Additional Annexure-23

Meeting of the Internal Committee constituted under MMDR Act 1957 for approval of Mining Plan / Mine Closure Plan was held on 01/09/2025 through Video Conference (VC) to consider Mining Plan and Mine Closure Plan for Sahapur East of M/s Mineware Advisors Private Limited

Additional Annexure-24

REPLY OF ADDITIONAL CLARIFICATION SOUGHT BY INTERNAL COMMITTEE				
Application No.	APP00339	Name of Mine	Sahapur East	Name of Project Proponent
Subject	Meeting of the Internal Committee constituted under MMDR Act 1957 for approval of Mining Plan / Mine Closure Plan was held on 01/09/2025 to consider Mining Plan and Mine Closure Plan for Sahapur East of M/s Mineware Advisors Private Limited.

ANNEXURE-2

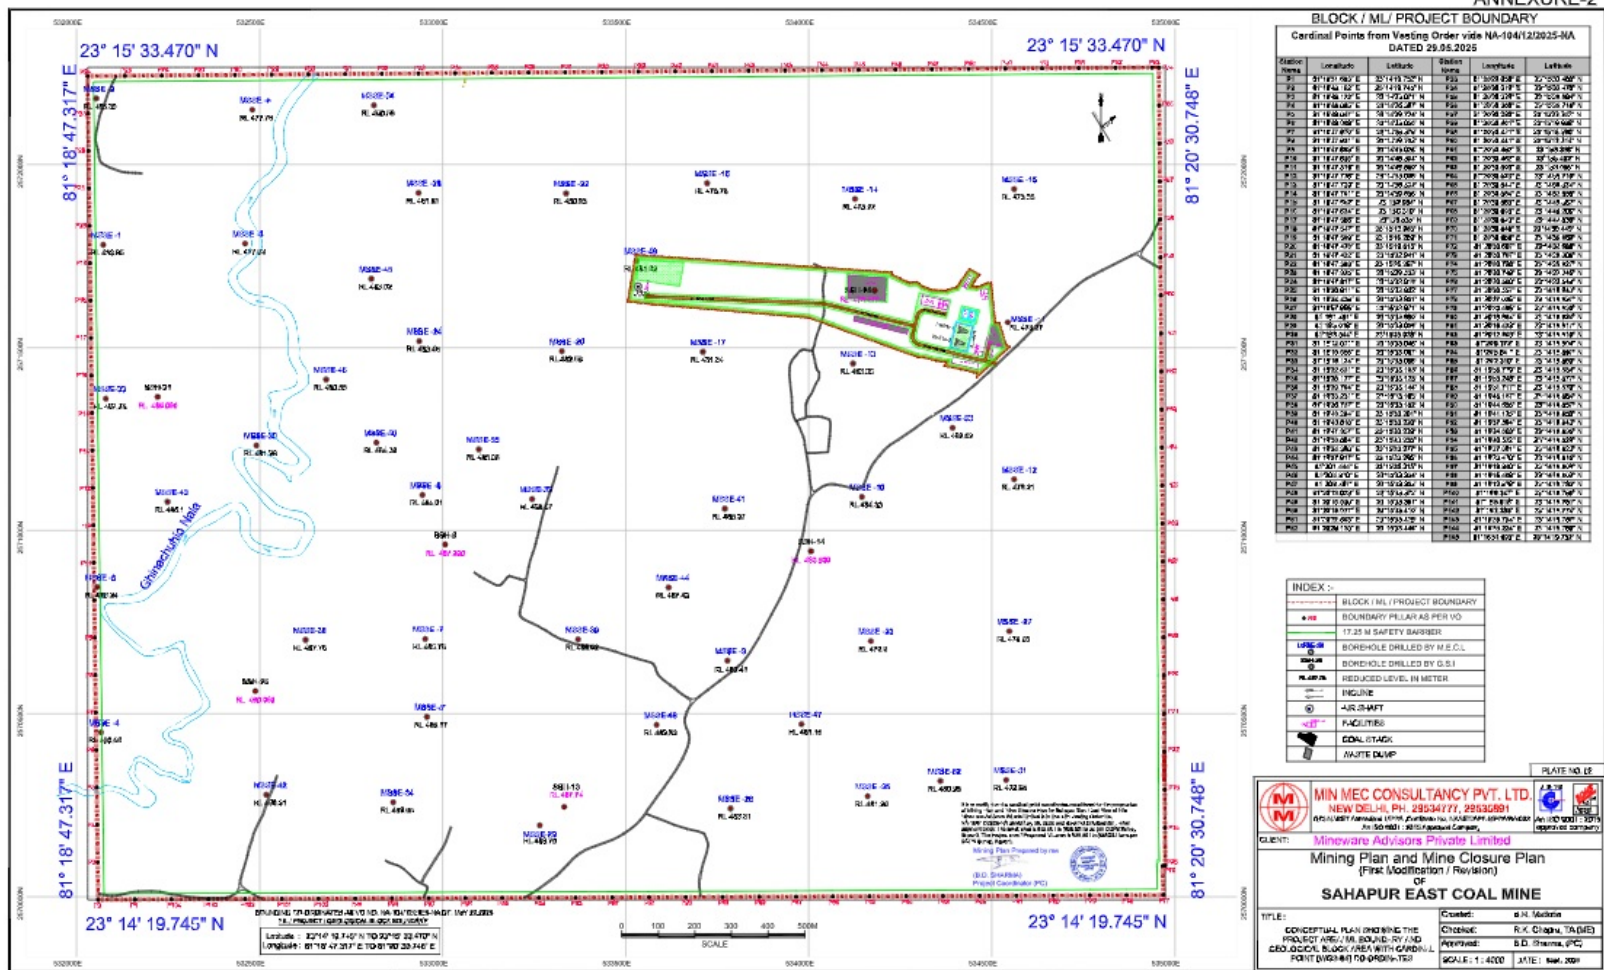
1 - (a) A plan shall be furnished showing geological block boundary, project area of earlier approved mining plan, geological boundary as given in GR and the geological block area, project area of the instant mining plan Extent of underground workings in the earlier approved mining plan and the instant mining plan shall be shown on the plan. (B) Plate-2A: Certification shall be done as per the guidelines.

S.N	Final Observation Details	Reply by Project Proponent
1.	(A) A plan shall be furnished showing geological block boundary, project area of earlier approved mining plan, geological boundary as given in GR and the geological block area, project area of the instant mining plan Extent of underground workings in the earlier approved mining plan and the instant mining plan shall be shown on the plan. (B) Plate-2A: Certification shall be done as per the guidelines.	(A) The required plan is enclosed as Annexure-1 . (B) Updated Plate-2A, certified as per guidelines, is enclosed as Annexure-2 .

Discrepancies in Sahapur East Block Boundary

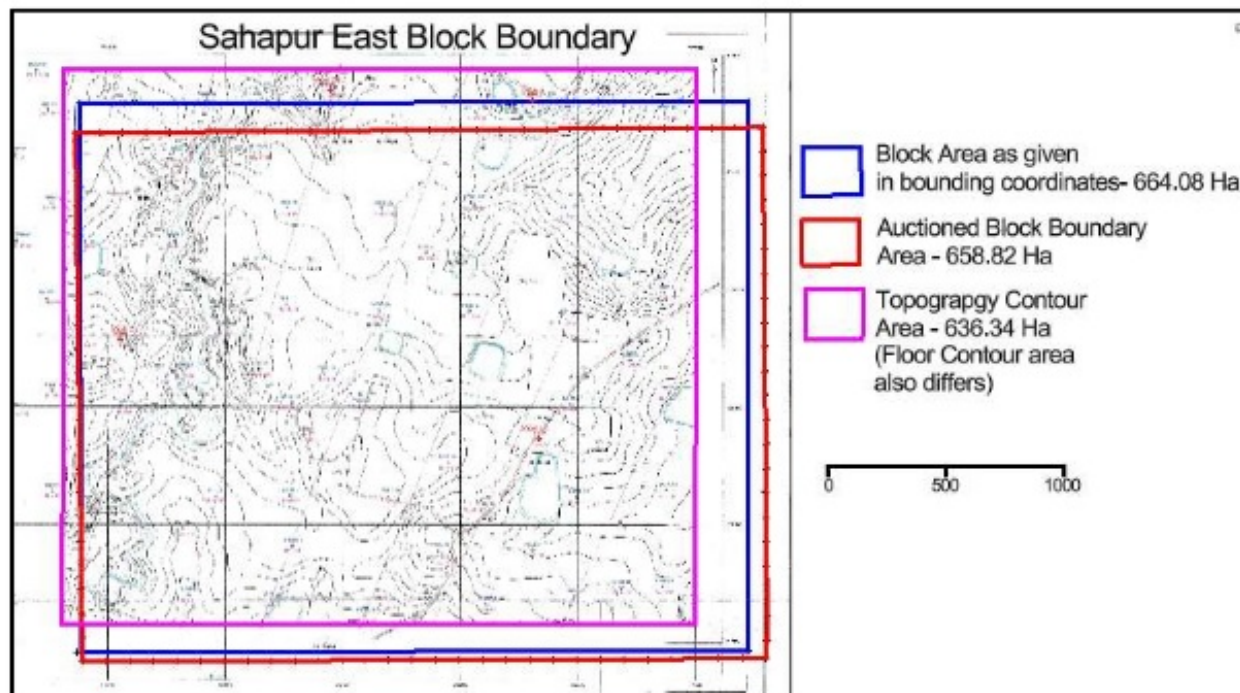
1. The GR prepared by MECL mentions the area as **640 hectares**.
2. When the bounding coordinates provided in the GR are plotted on CAD, the area comes out to be **664 hectares**.
3. The boundary shown in the plates of the GR covers an area of **636 hectares**.
4. The **unexplored area** between:
 - o Bounding Coordinates and Floor Contour Plates is **82 hectares**;
 - o Auctioned Block Boundary and Floor Contour Plates is **106 hectares**.
5. A discrepancy of **28 hectares** exists between the auctioned block boundary and the bounding coordinates.

1. In mine block summary the area is said to be 659 Ha with 105 cardinal points against which the block was auctioned.
2. MECL prepared the geological report of the Sahapur East block with the area of 640 Ha.
3. The GR prepared by MECL the bounding coordinates are showing the area to be 664 Ha.
4. Between Bounding Coordinates and Floor Contour plates – Unexplored area is 82 Ha.
5. Between Auctioned Block boundary and Floor Contour plates – Unexplored area is 106 Ha.
6. Area difference between auctioned block boundary and bounding coordinates is 28 Ha.

Due to the above mismatch in boundaries, there is area within the auctioned block boundary with missing floor and roof contours of coal seams. This does not allow preparation of Mining Plan for the 659 Ha of auctioned boundary.

Sir,
With respect to your letter dated: 02.05.2025, it is to mention that the area of the Shahpur East coal block as mentioned in mine summary is 659 Ha. The same block boundary is certified by CMPDI dated 30.08.2021. The required floor contour plans are attached above.
